# UNITED STATES PATENT AND TRADEMARK OFFICE

APPLICATION NO.	FILING DATE	FIRST NAMED INVENTOR	ATTORNEY DOCKET NO.	CONFIRMATION NO.
10/740,255	12/18/2003	Michael John Rutter	CHM-019	1904
38155	7590	10/04/2004	EXAMINER	
HASSE GUTTAG & NESBITT LLC 7550 CENTRAL PARK BLVD., MASON, OH 45040			MITCHELL, TEENA KAY	
			ART UNIT	PAPER NUMBER
			3743

## Office Action Summary

## DETAILED ACTION

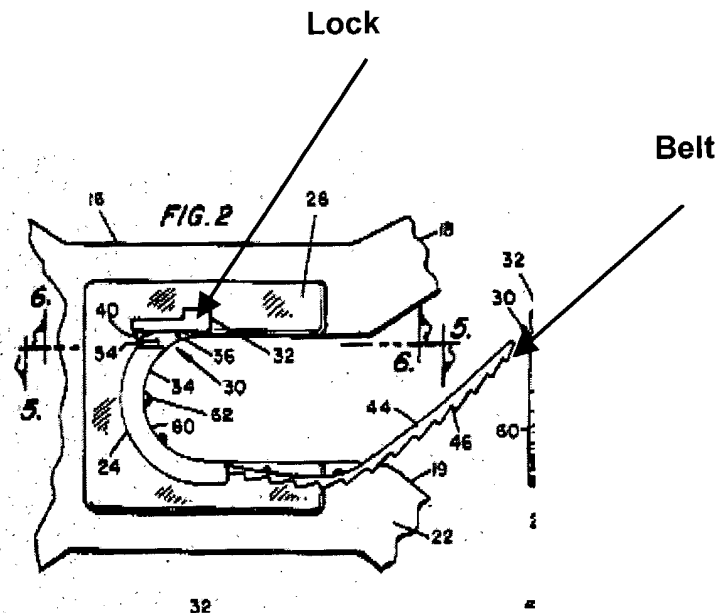
Claims 2, 3, 6-8, 10, 11, and 14-20 are rejected under 35 U.S.C. 103(a) as being unpatentable over Beran (4,516,293).

With respect to claims 7 and 11, Beran discloses a retainer strip underlies the domes (44), as for the strip being a plastic note rejection of claim 2 above.

With respect to claim 8, Beran discloses wherein the strip comprises a lock at one end (32) and a belt at the other end (see illustration of Fig. 2 below).
